REGULAR CALENDAR
STAFF REPORT AND PRELIMINARY RECOMMENDATION

Application No.: 6-01-160

Description: Construction of an approximately 80 ft.-long, 13 ft.-high and 27 in.-thick tiedback concrete seawall incorporating two rows of approximately 30 ft.-long rock anchors.

Site: On the public beach below 252 and 258 Neptune Avenue, Encinitas, San Diego County. APNs: 256-352-13 and 256-352-12

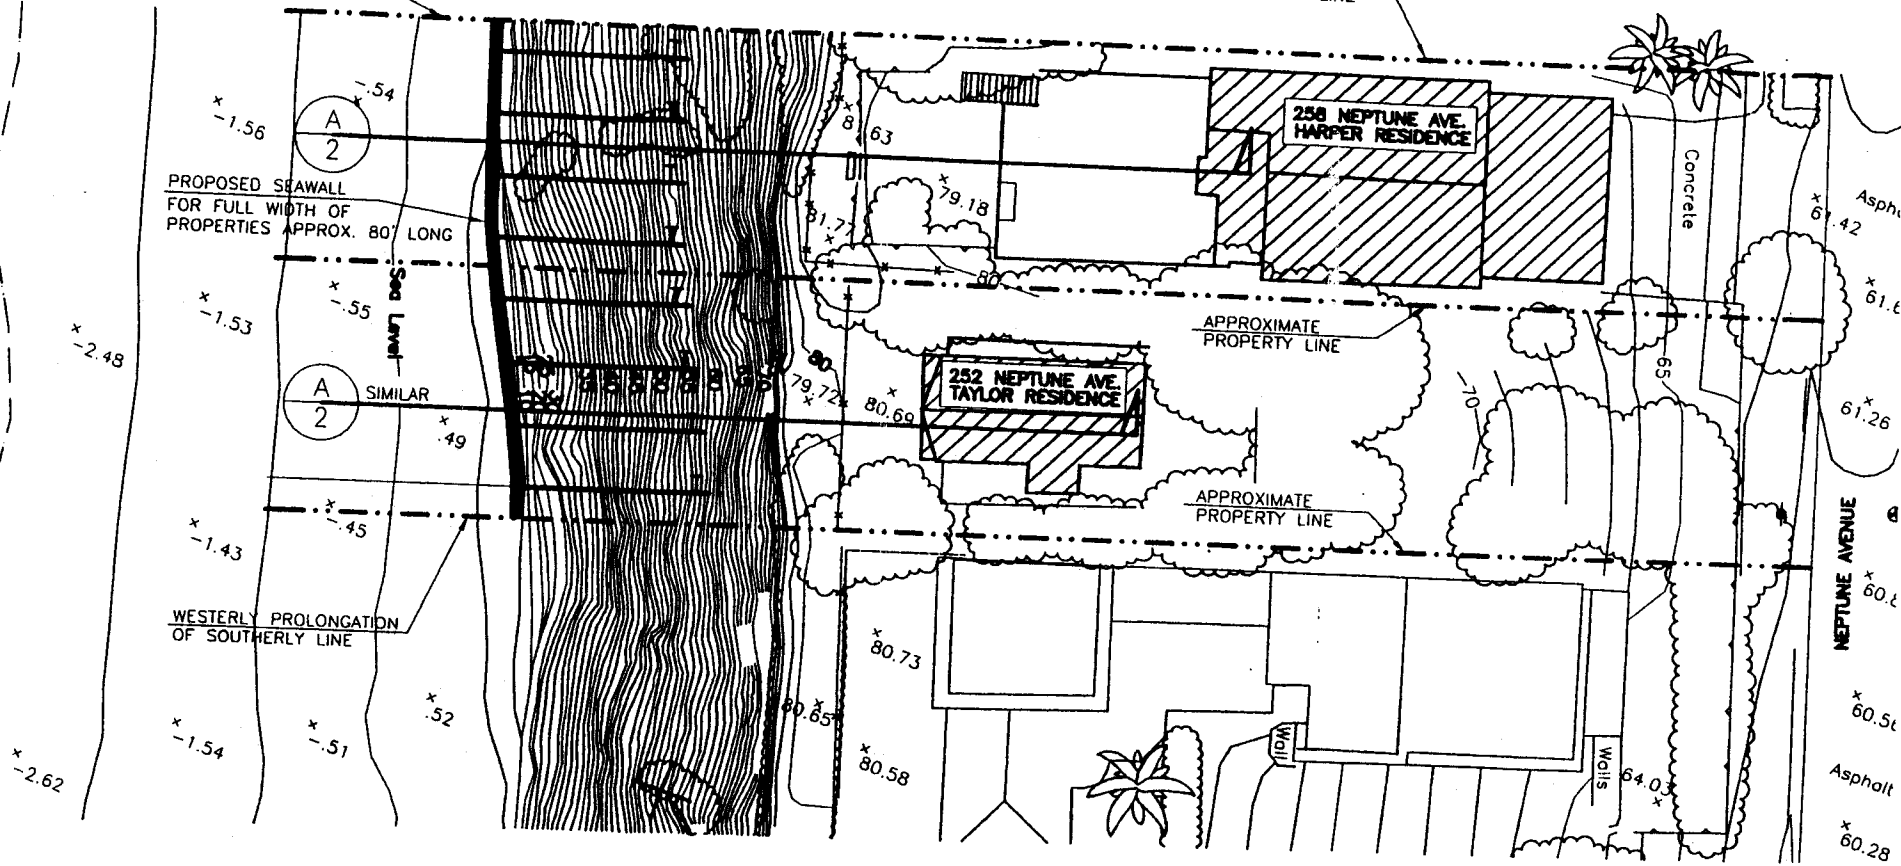
- 5) Clarification of the line of cross section in reference (4)—since both sections marked on the plan are labeled "A2," it is difficult to say with certainty which line is used for the section.

- 6) Clarification of the actual principal structure at 258 Neptune Avenue (reference 4). Is the outlined area west of the hatched area an enclosed, principal structure (in which case the setback from the bluff top is ~30 feet) or is it only a deck or patio (in which the setback of the principal structure is over 60 feet).

Encinitas Bluff stability:
CDP Application 6-01-053:
Analysis Method: Bishop
Slip Surface Option: Grid and Radius
P.W.P. Option: (none)
Tension Crack Option: (none)
Seismic Coefficient: (none)

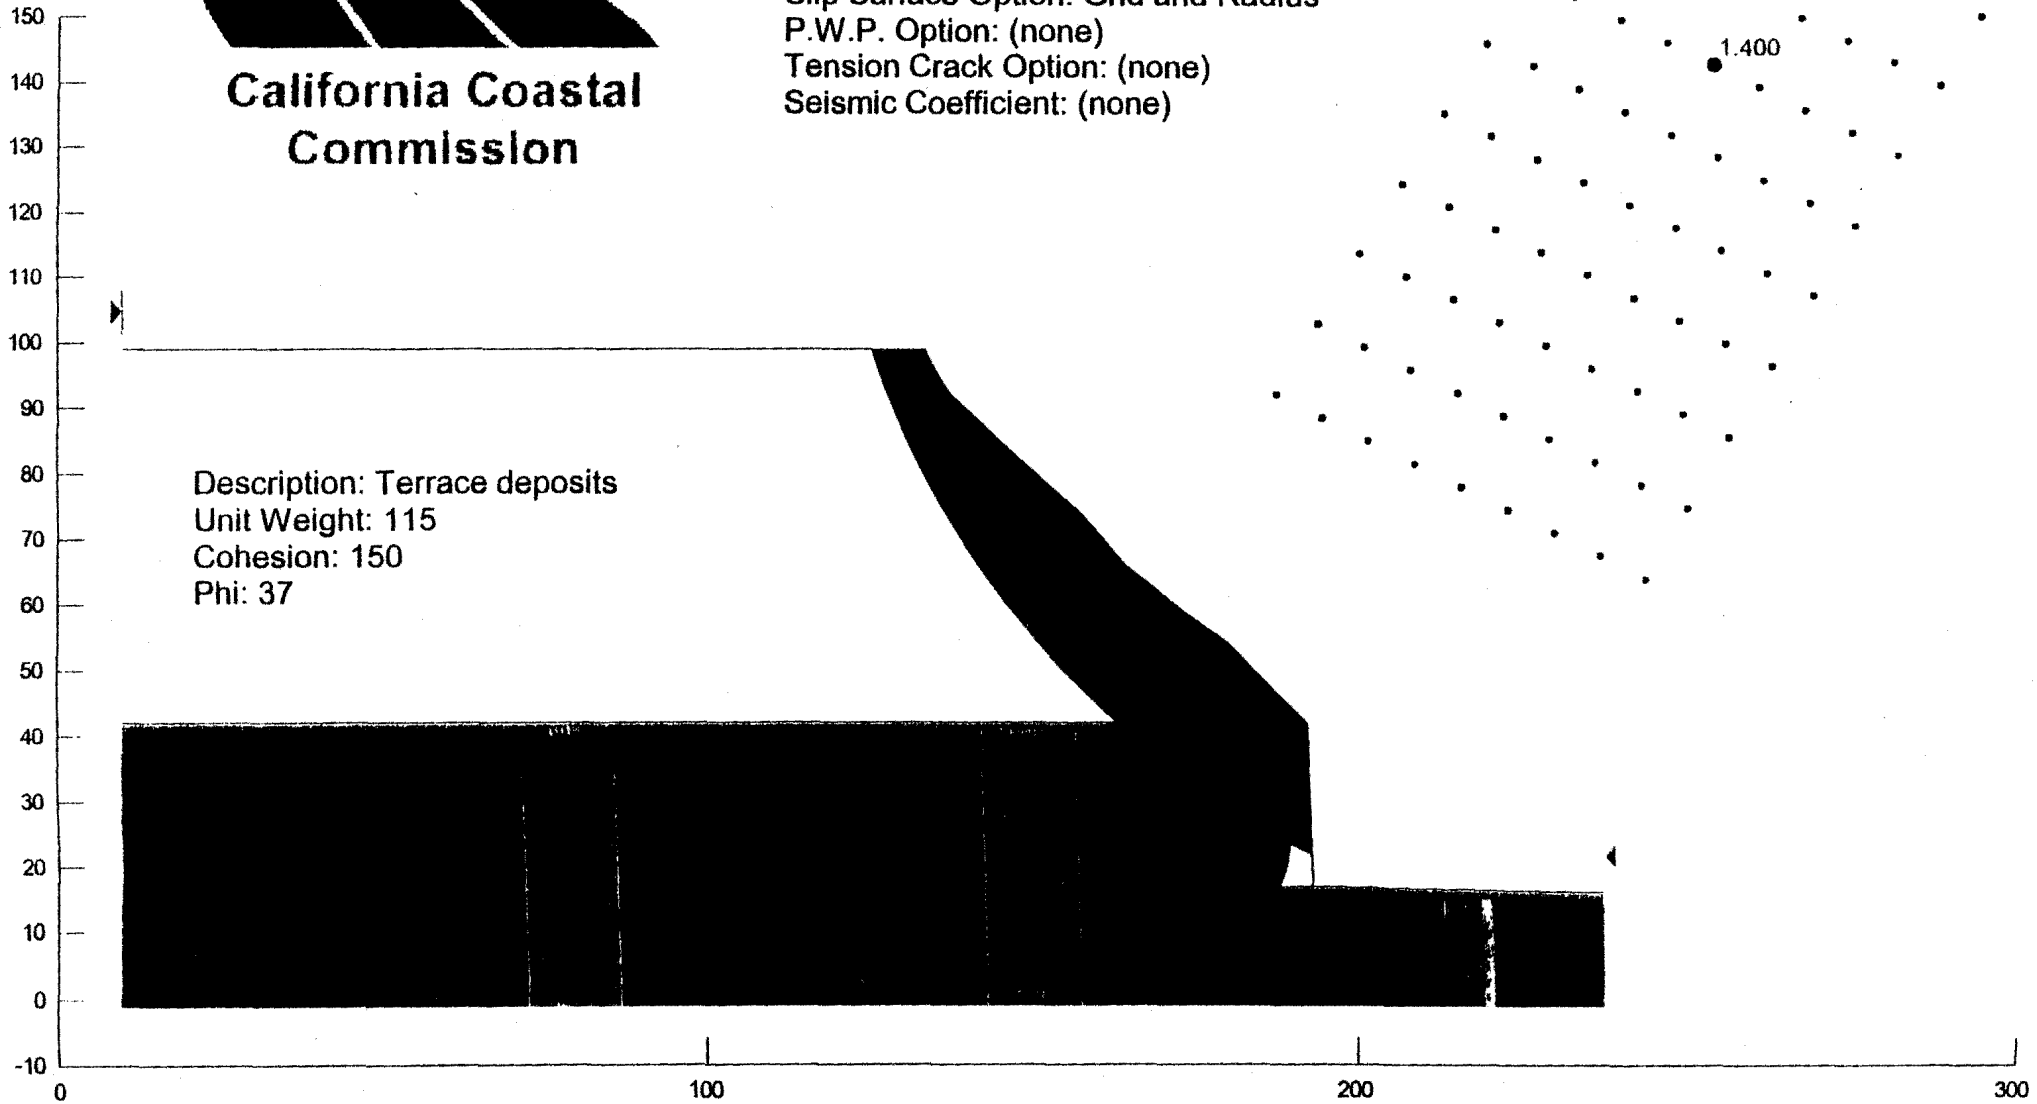
I have since modeled the stability of the bluff myself, using the more overhanging of the two bluff geometries (below 310 Neptune Avenue) as provided in figure 3 of the document referenced above. Although I used the same input parameters (unit weight, cohesion, friction

angle) and similar analysis methods as in the 17 March 2000 and 7 April 2000 Soil Engineering Construction reports, I was unable to reproduce the reported low factors of safety for the overall stability of bluff. My analysis showed a static factor of safety of 1.400 using the Bishop method, and 1.398 using the mathematically more rigorous Morgenstern-Price method (see attached figures). Although these figures are below the figure of 1.5 generally required for new construction, they do show that the bluff is not in imminent danger of failure through a mechanism involving collapse of the entire bluff along a failure plane extending uninterrupted through the Torrey sandstone and the overlying terrace deposits.
